RE: DRAINAGE PLAN FOR LOT 1514 OF SANDIA HEIGHTS SOUTH, UNIT 15 (D-23/D15) ENGINEER'S STAMP DATED APRIL 21, 1988

REFERENCE: Grading and Drainage Plan for Lot 198, Unit 2, Sandia Heights South (C-23/D15)

RE: REVISED DRAINAGE PLAN FOR LOT 198, UNIT 2 OF SANDIA HEIGHTS SOUTH (C-23/D15) RECEIVED AUGUST 23, 1989

RE: DRAINAGE PLAN FOR LOT 198, UNIT 2 OF SANDIA HEIGHTS SOUTH
(C-23/D15) RECEIVED AUGUST 11, 1989 BP89-509

RETAING WALL FOR MORROW CONST.

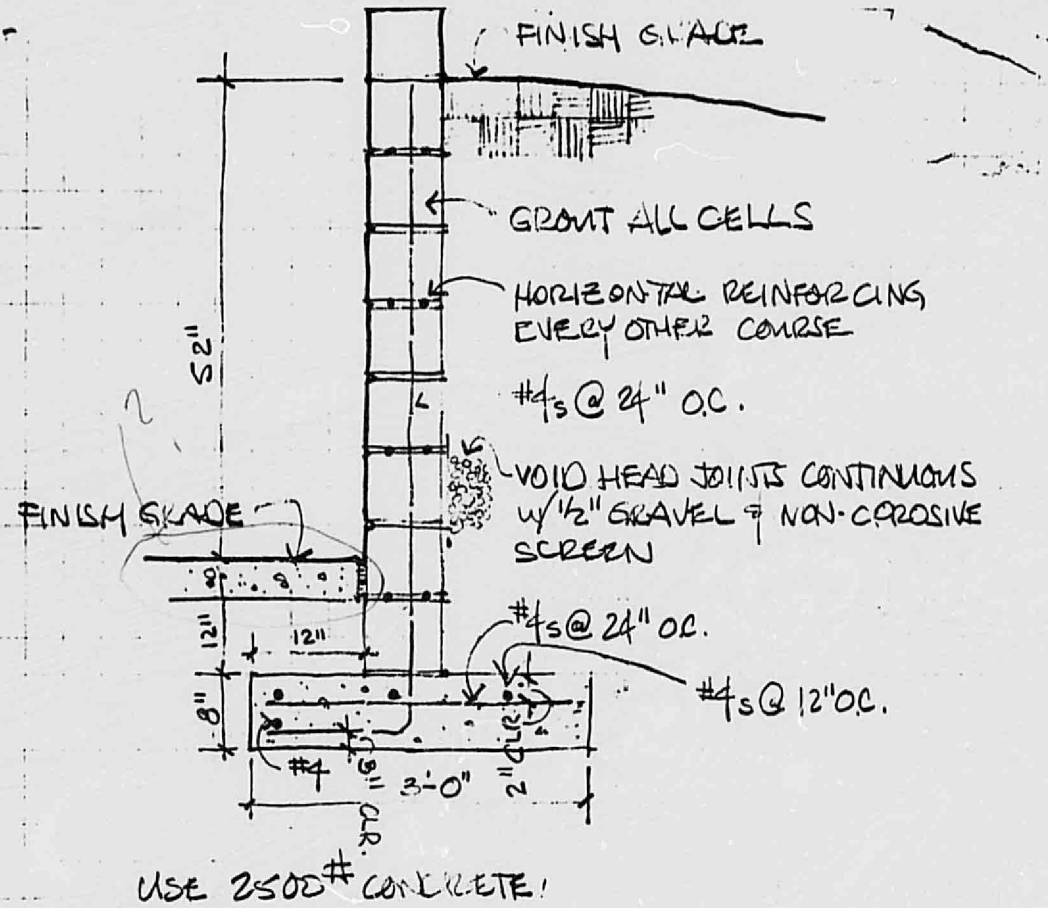
4. On your dike wall detail, please identify which side is east and which side is west.

4. The east and west sides of the dike are shown.
